J2025-0049
PSP2025-0003
Revision #3
Received 11/26/2025

Site Plan Review
Reviewed for compliance with City Ordinance, Building and Fire Codes
Conditions and mark-ups noted throughout plan set must be addressed prior to final
approval

TIMBERLAND LANDSCAPE

Site Plan

COVER SHEET
TIMBERLAND LANDSCAPE

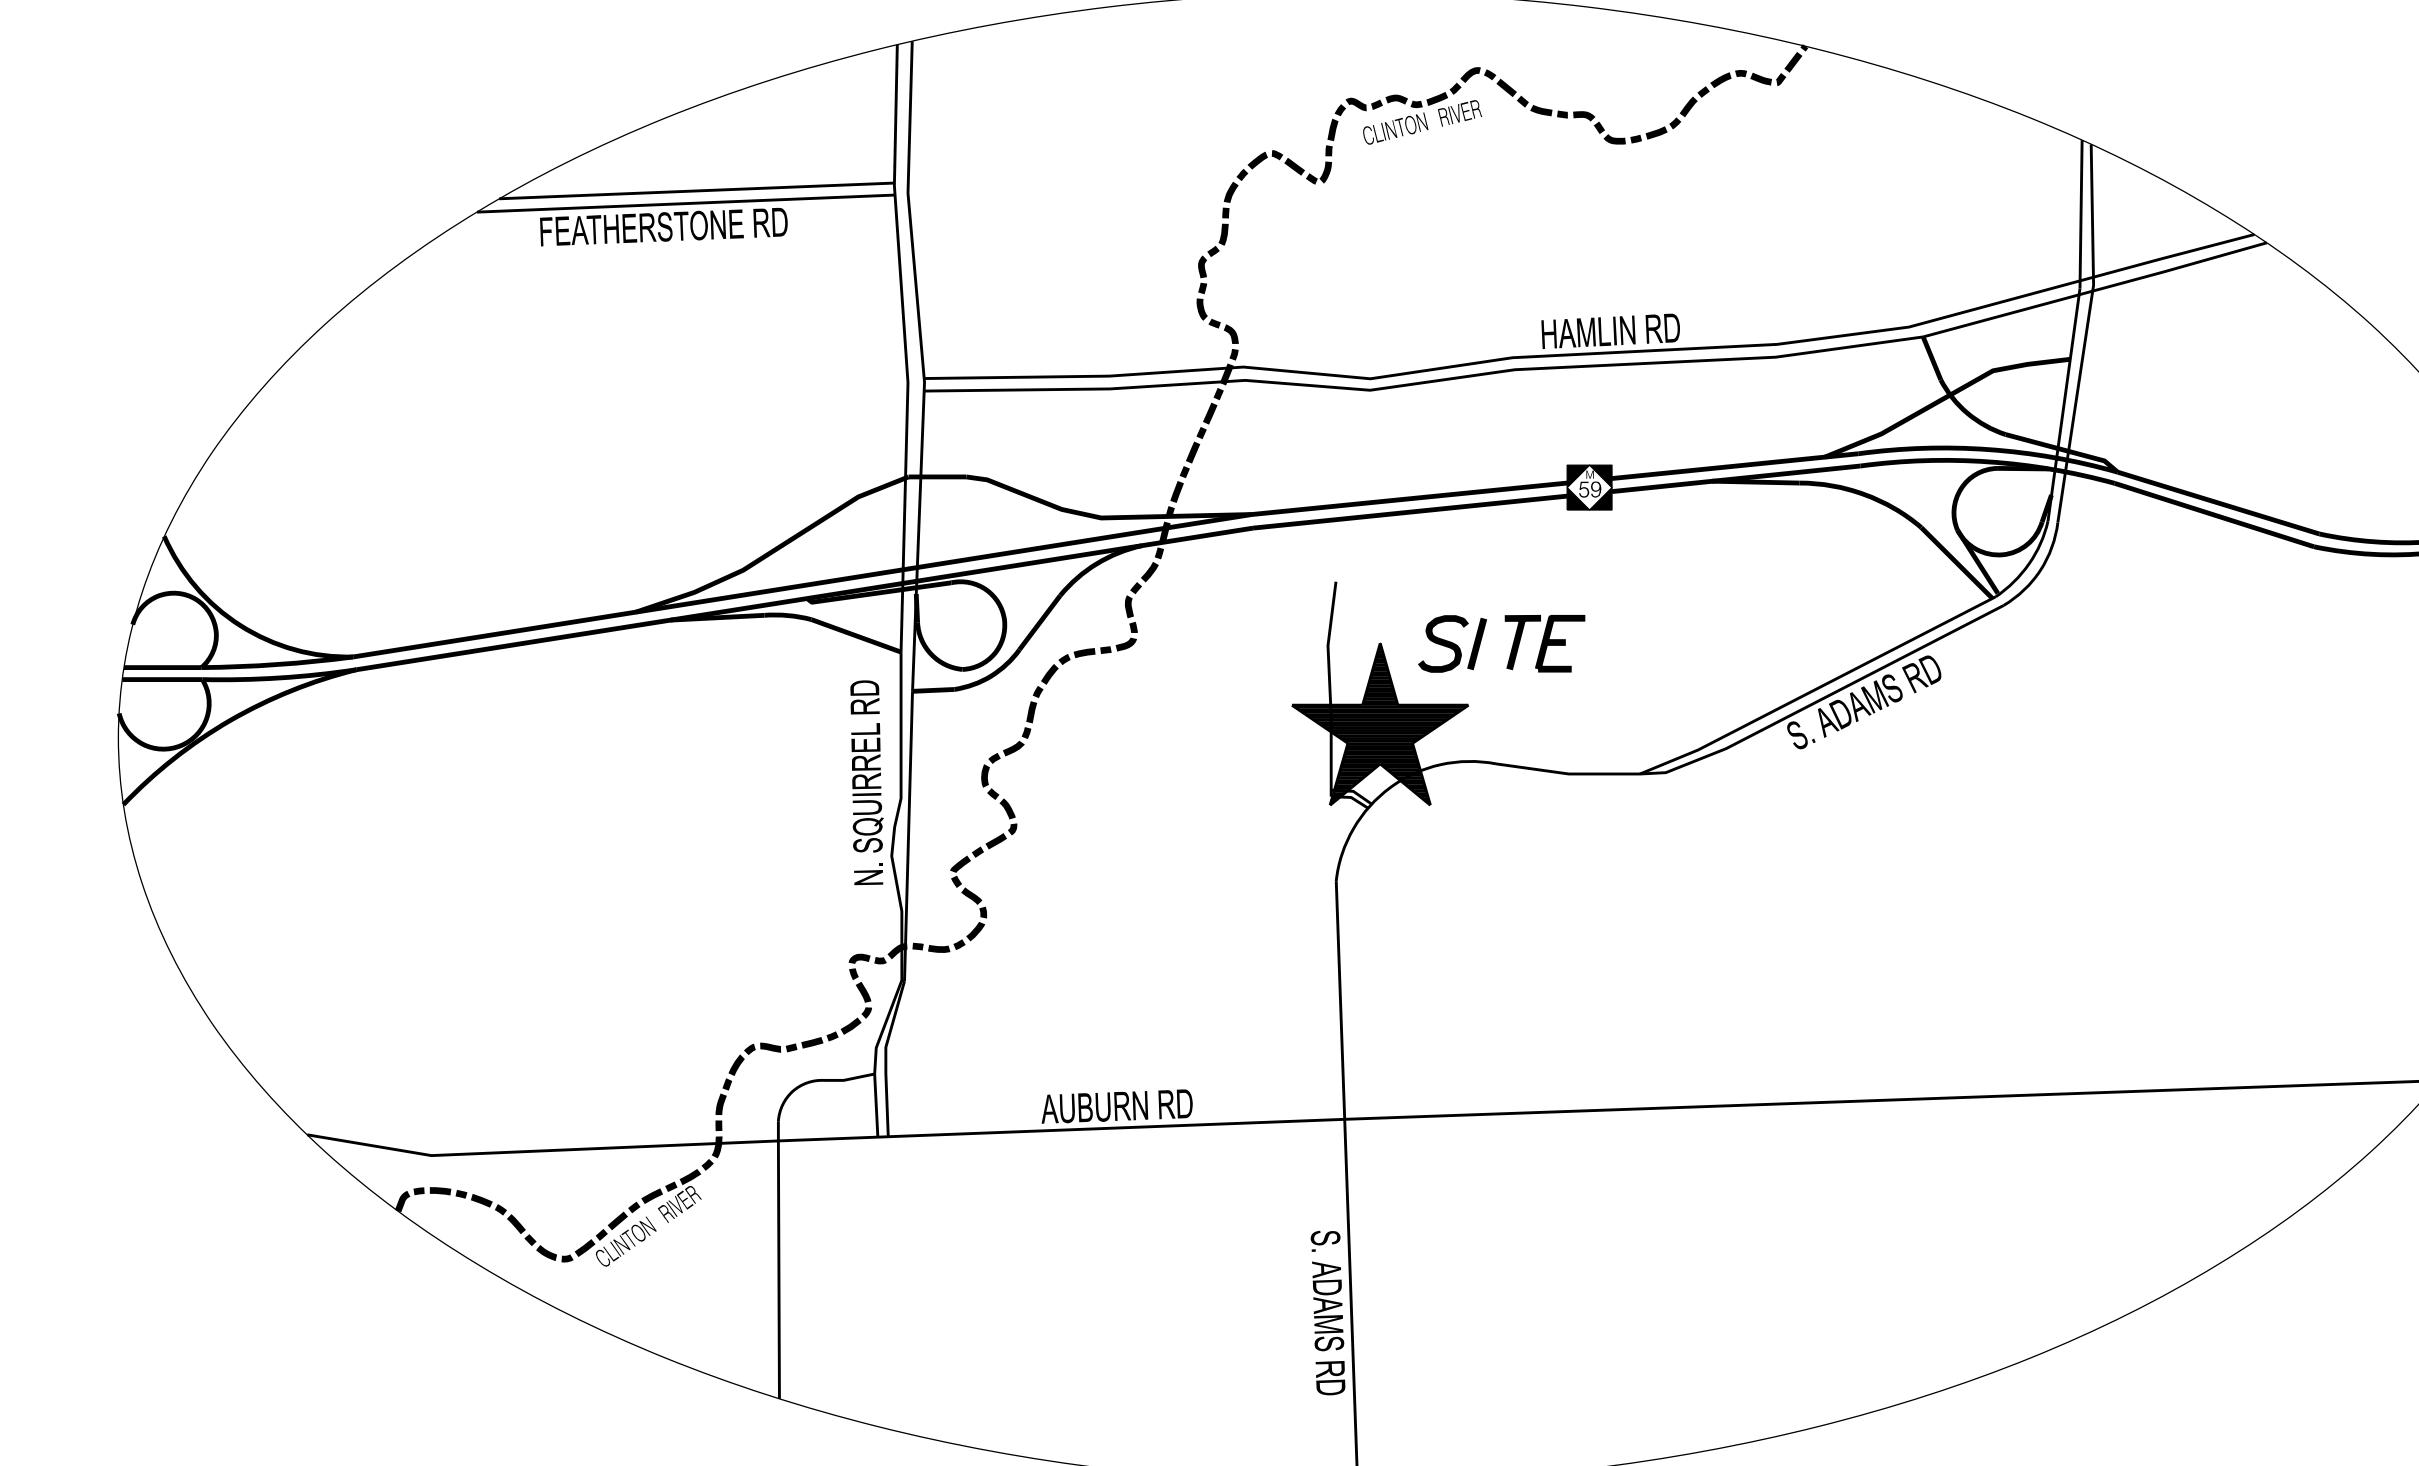
Tree Removal Permit = Remove 26 Trees, 17 Trees to Remain, Plant 4 trees, 19 Trees Paid into Tree Fund

In lieu of payment into tree fund, trees should be planted along berm/road frontage

Next Steps: The applicant should coordinate with Planning Staff for **LAND USE** and **2005 PONTIAC RD** attending January Planning Commission meeting.

EXISTING CONDITIONS
TIMBERLAND LANDSCAPE

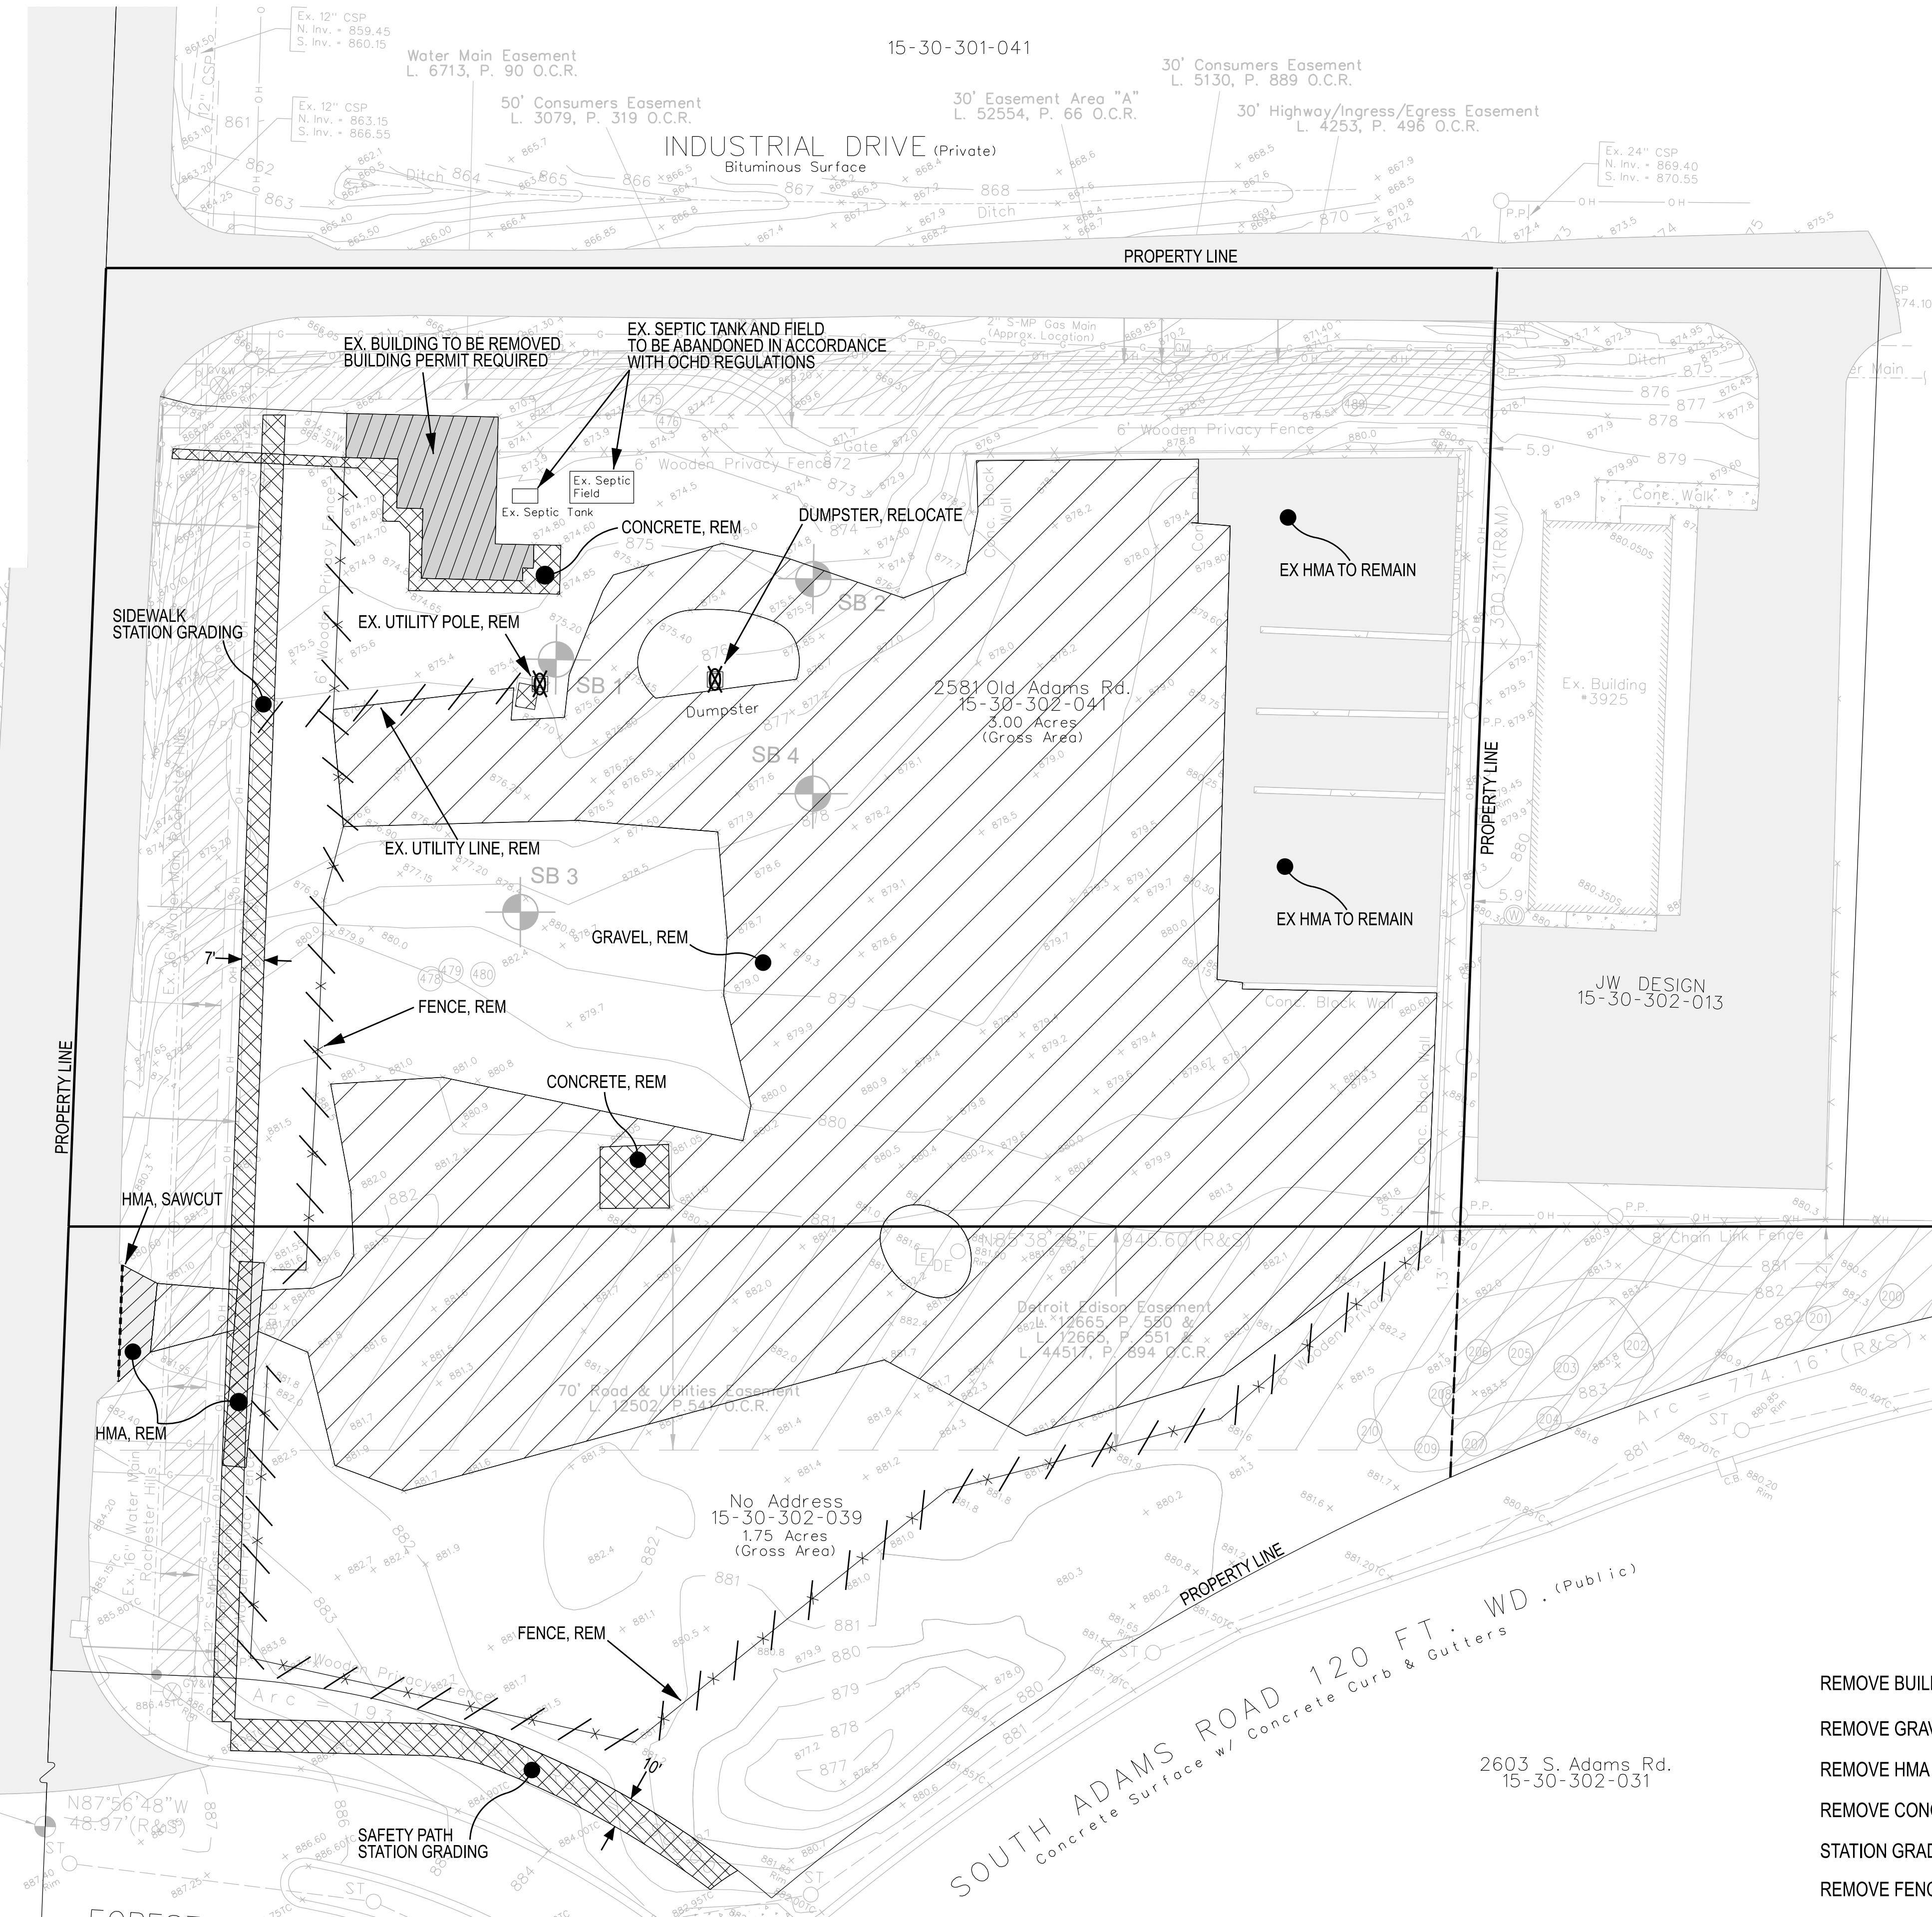
If area is not dedicated to RCOC, appropriate landscaping pursuant to ordinance will be required in this area.

Hot-Mixed Asphalt Pathway Construction, Extensions and Relocations

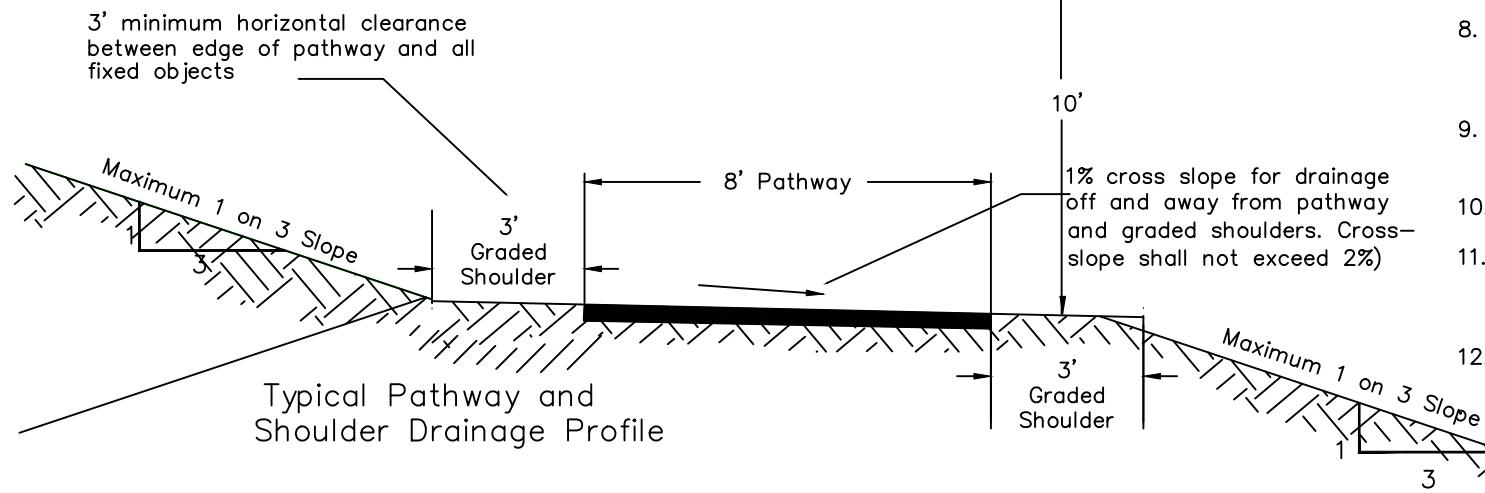
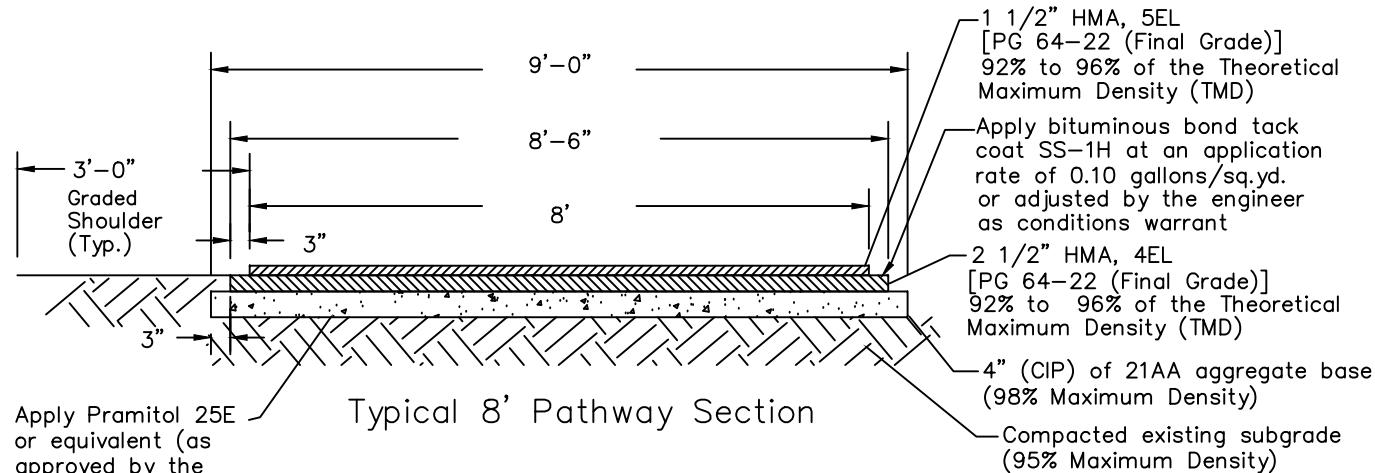
Use the updated Pathway Standard Detail. Minor changes were recently made to the Standard Notes.

1. Maximum grade of 5% along mainline pathway. Maximum grade at ramps 8.33% (recommended for 5%).
2. 1% cross slope (i.e. super elevation) for drainage off and away from pathway and graded shoulders (2% maximum cross-slope).
